Contract #: 04-0120F4Cty: SF/ALA Rte: 80 PM: 13.2/13.9File #: 69.28**WELDING INSPECTION REPORT****Resident Engineer:**Pursell, Gary**Address:** 333 Burma Road**City:** Oakland, CA 94607**Report No:** WIR-002151**Date Inspected:** 23-Apr-2008**Project Name:** SAS Superstructure**OSM Arrival Time:** 700**Prime Contractor:** American Bridge/Fluor Enterprises, a JV**OSM Departure Time:** 1700**Contractor:** Zhenhua Port Machinery Company, Ltd (ZPMC), Changxing Island **Location:** Shanghai, China**CWI Name:** Xu Le Feng, Ye Yong Jun**CWI Present:** Yes No**Inspected CWI report:** Yes No N/A**Rod Oven in Use:** Yes No N/A**Electrode to specification:** Yes No N/A**Weld Procedures Followed:** Yes No N/A**Qualified Welders:** Yes No N/A**Verified Joint Fit-up:** Yes No N/A**Approved Drawings:** Yes No N/A**Approved WPS:** Yes No N/A**Delayed / Cancelled:** Yes No N/A**Bridge No:** 34-0006**Component:** Tower**Summary of Items Observed:**

77M Tower Mock-up Macro Etch Samples

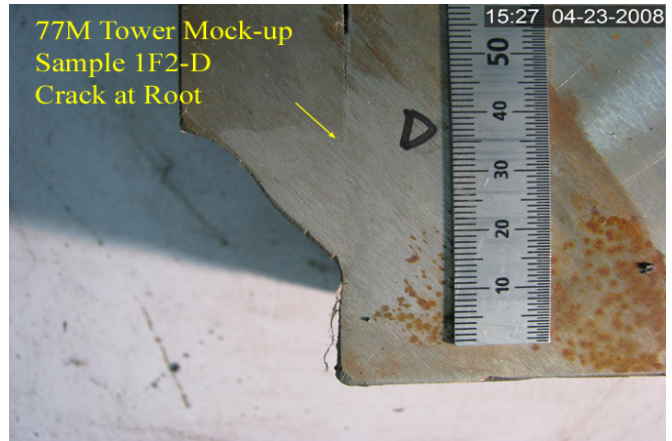
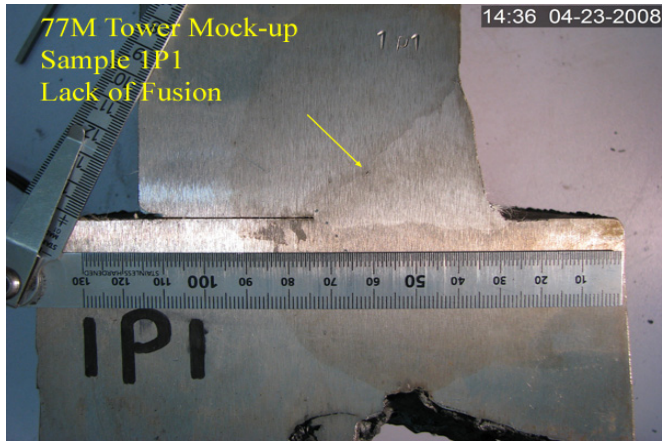
The Quality Assurance Inspector performed a visual inspection to forty two macro etch sample welds from the 77M Tower Mock up. One Sample was not provided as indicated from sample map ZPMC provided. All the data from the review was recorded in a tracking log and forwarded to Quality Assurance Task Leaders and Structural Materials Representatives. The Samples were digitally photographed and placed on the internal server for future review. Below are digital photograph of samples 1P1 which contained Incomplete Fusion and Sample 1F2-D which contained a crack in the root of the fillet weld.
